KINCH SUBDIVISION Construction Drawings El Paso County, Colorado

TITLE SHEET

| NO. | REVISION | BY | DATE |
|-----|---------------|-----|---------|
| 1 | EPC SUBMITTAL | JPS | 1/10/22 |

PLAN & PROFILE KINCH COURT

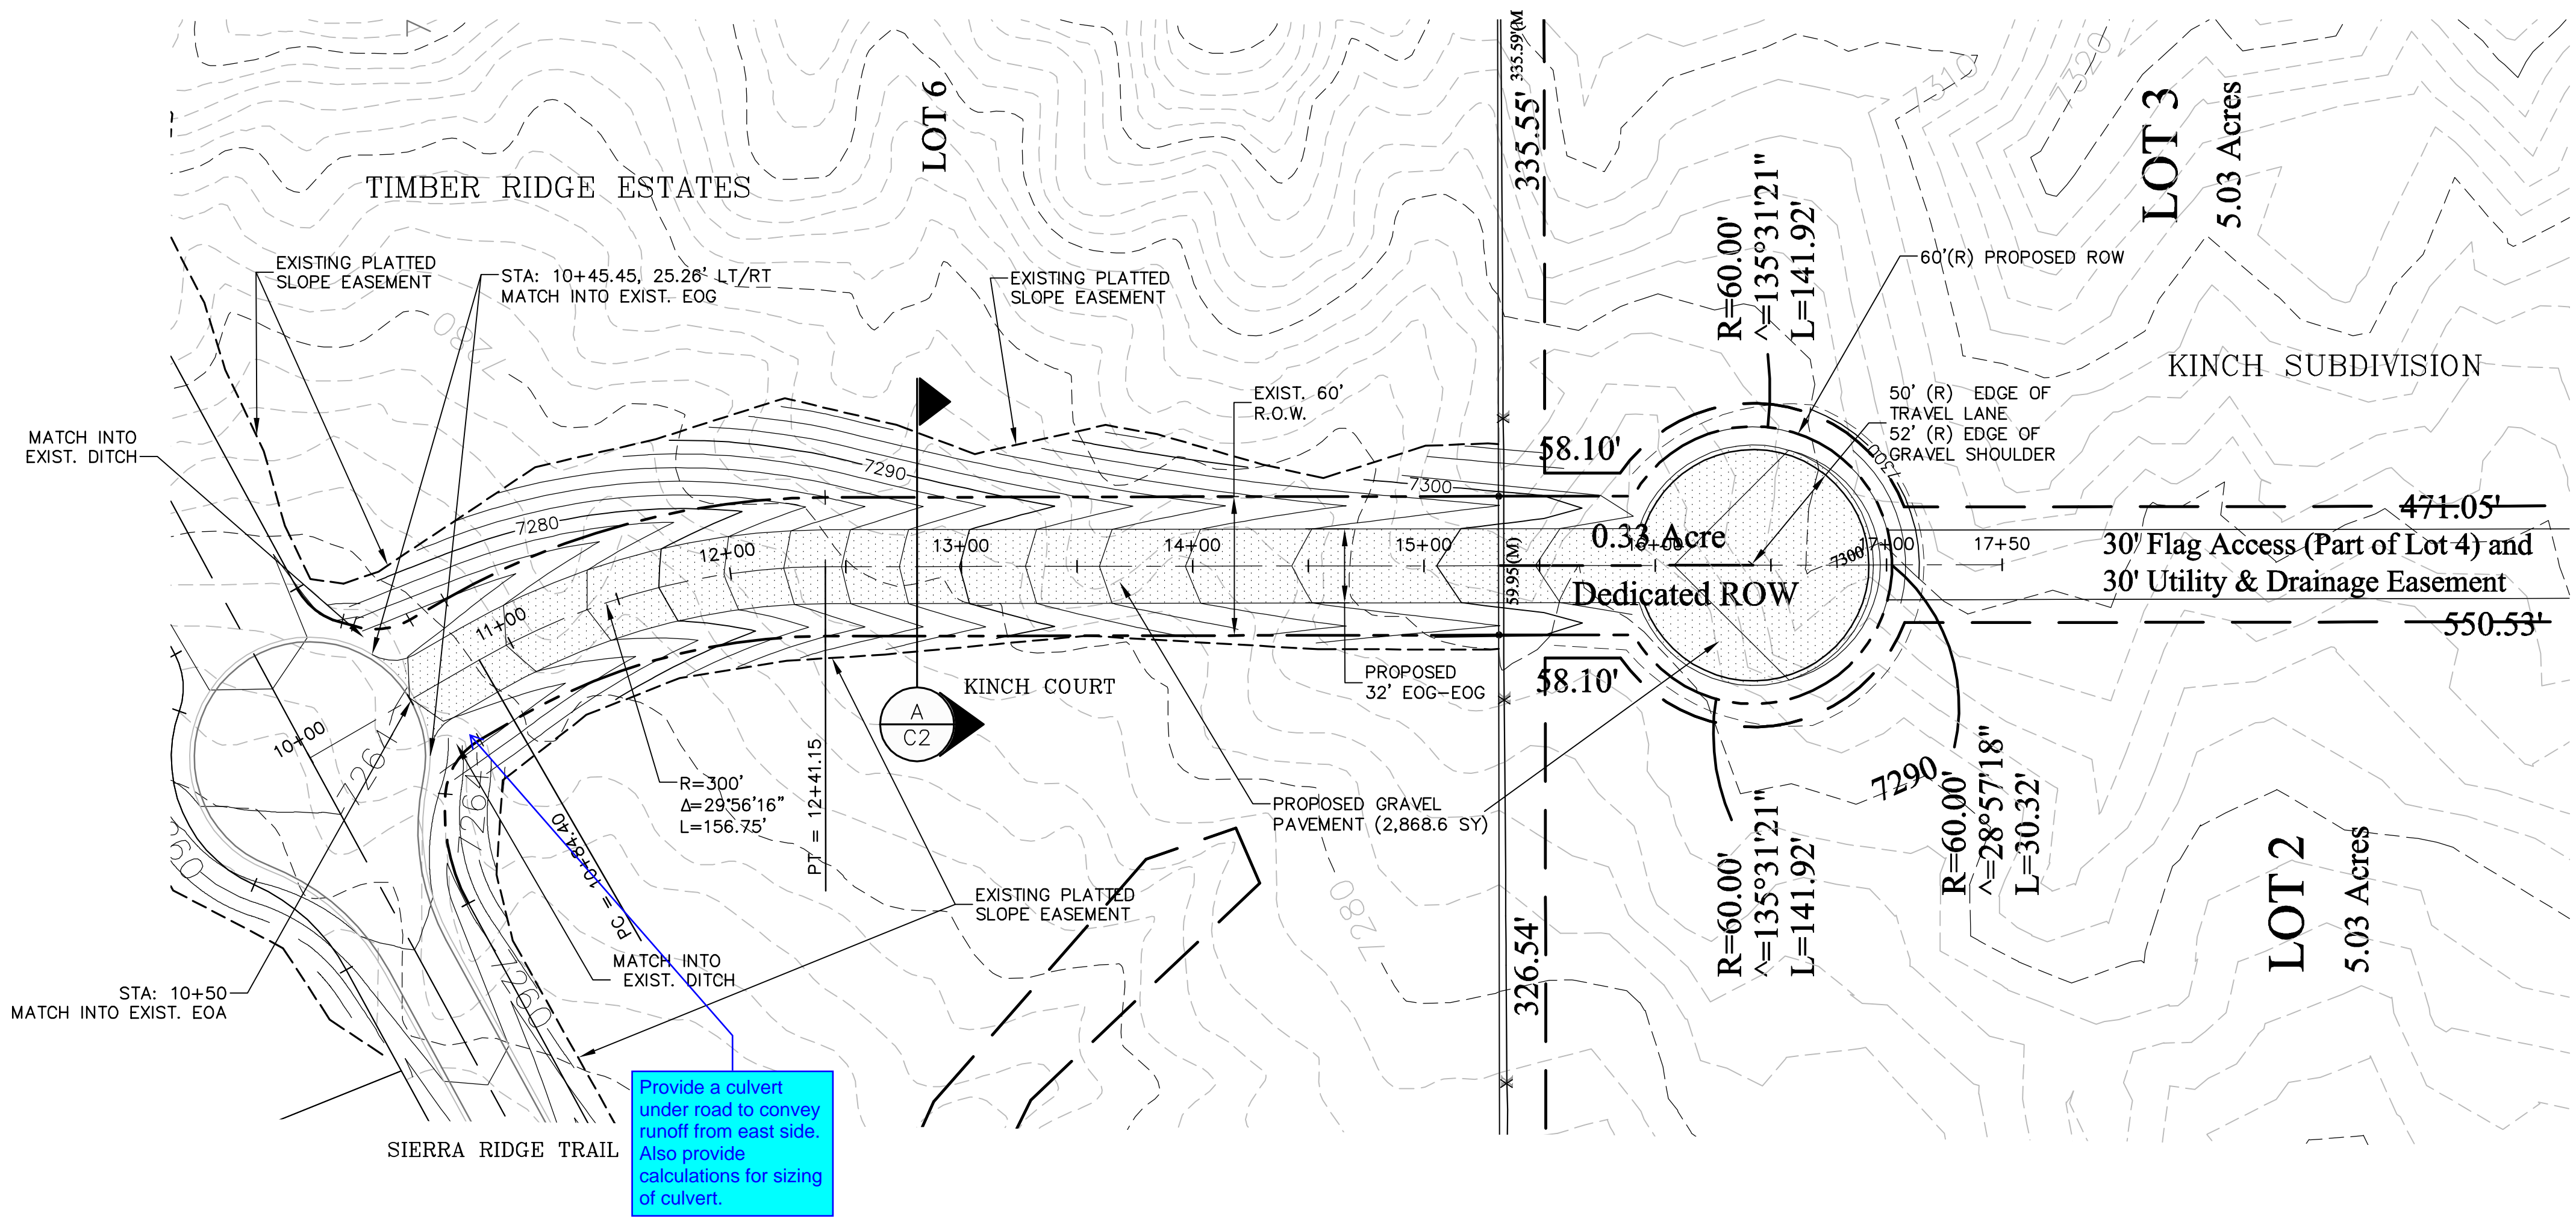
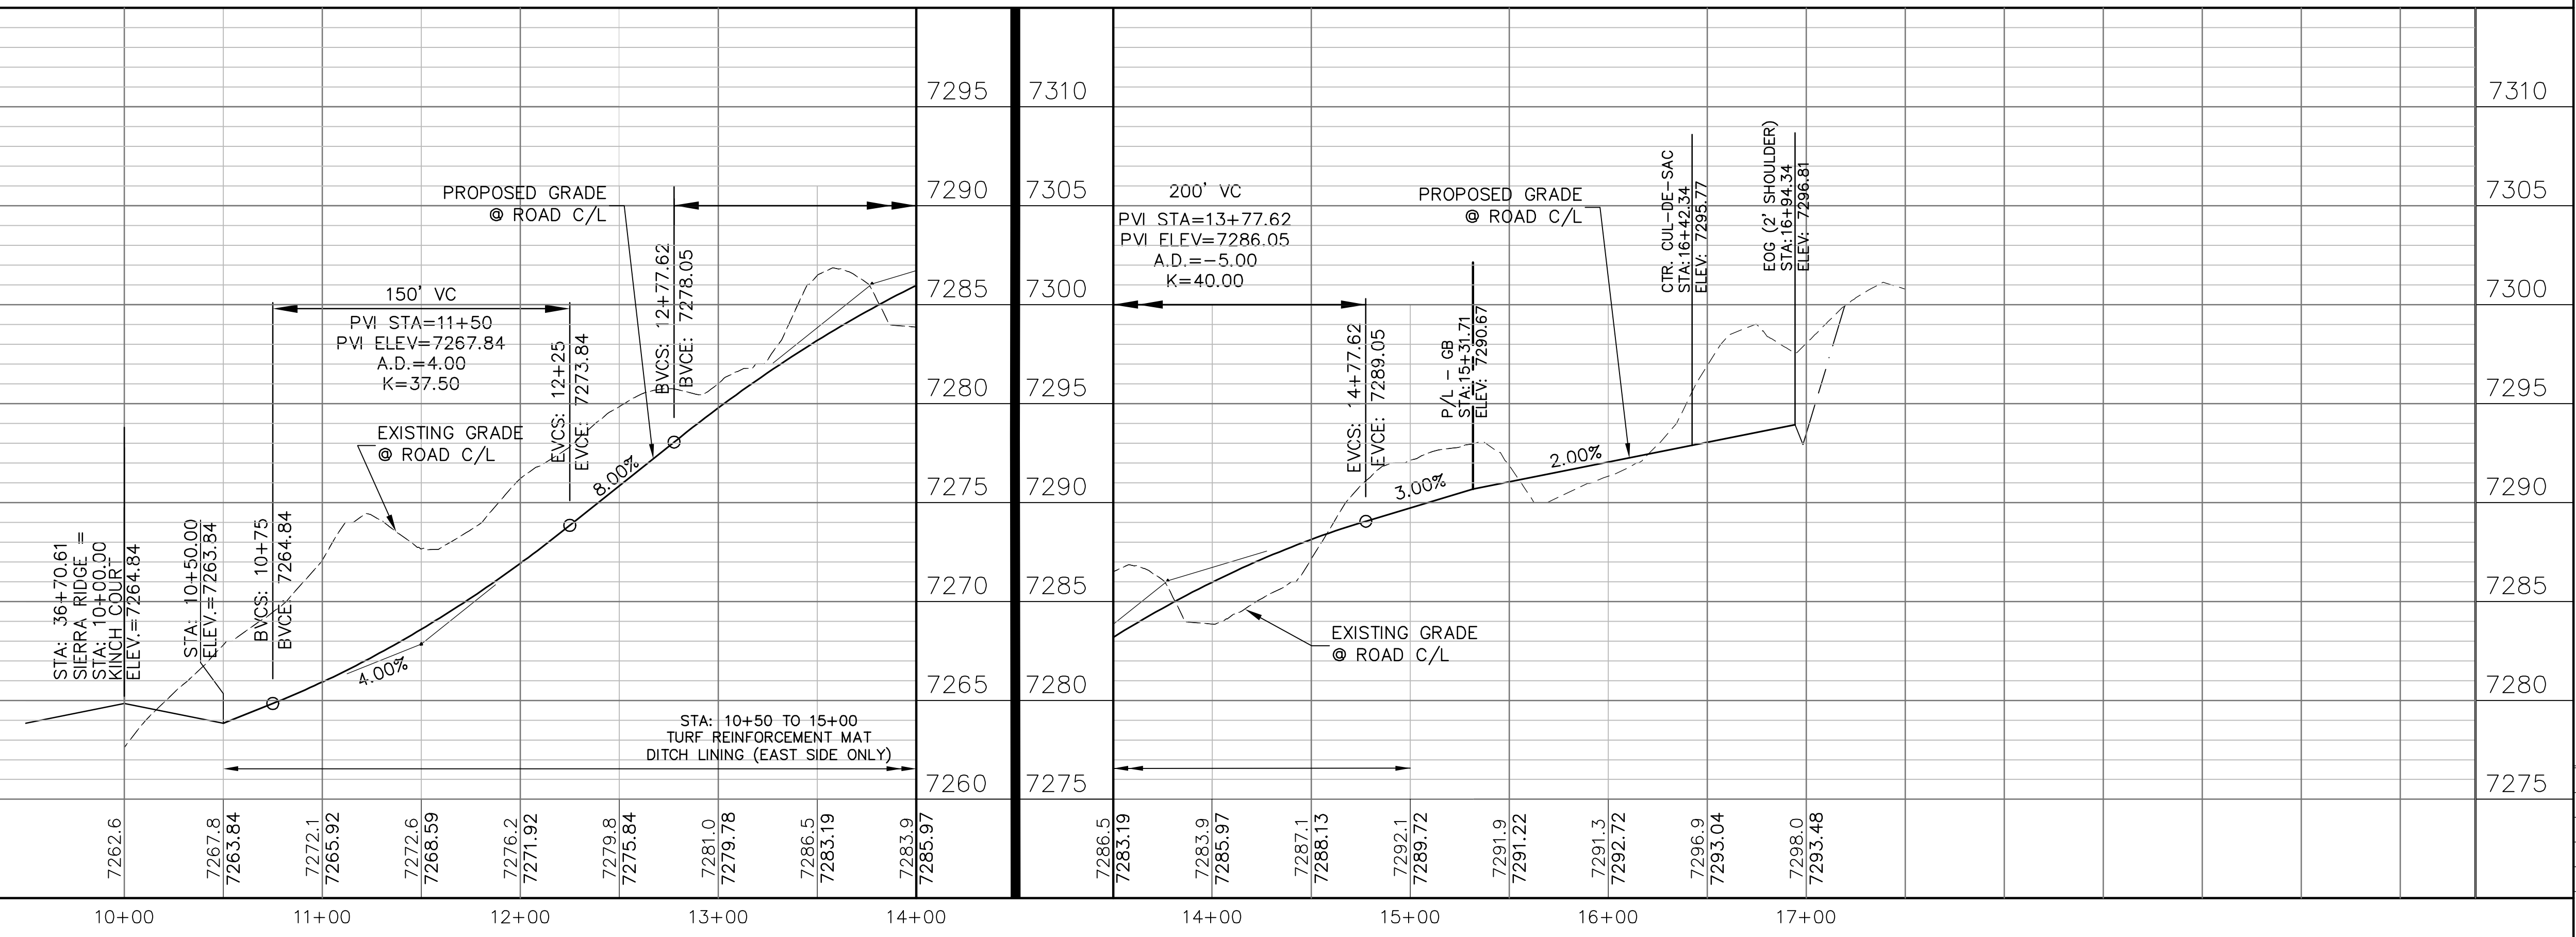
Please show the following:

- Ditch flowlines on profile, per ECM 2.5.8.C ditches shall have a minimum depth of 24 inches.
- Update plan to show entire limits of construction and disturbance. The grading and erosion control plan shows limits of construction and disturbance that extend onto the majority of Sierra Ridge Trail. If any grading is being proposed to Sierra Ridge Trail update the plan and profile to show proposed changes. Please note: Sierra Ridge Trail is County owned and maintained and a Work in the ROW permit will be required to do any work within public ROW. At the moment it is unclear what changes are proposed to Sierra Ridge Trail.
